HAWK ESTATES

SW15-00051

COVER SHEET

CITY OF ISSAQUAH - ENGINEERING REVIEW
APPROVED
ALL WORK SUBJECT TO FIELD INSPECTION
5/10/2016

NO PARKING SIGN DETAIL

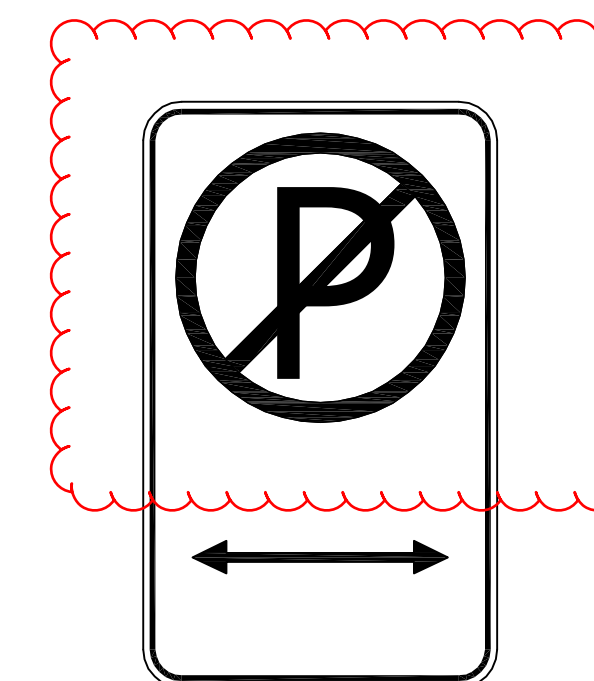
City of Sammamish
approval requiredProvide "No Parking
Fire Lane" on sign
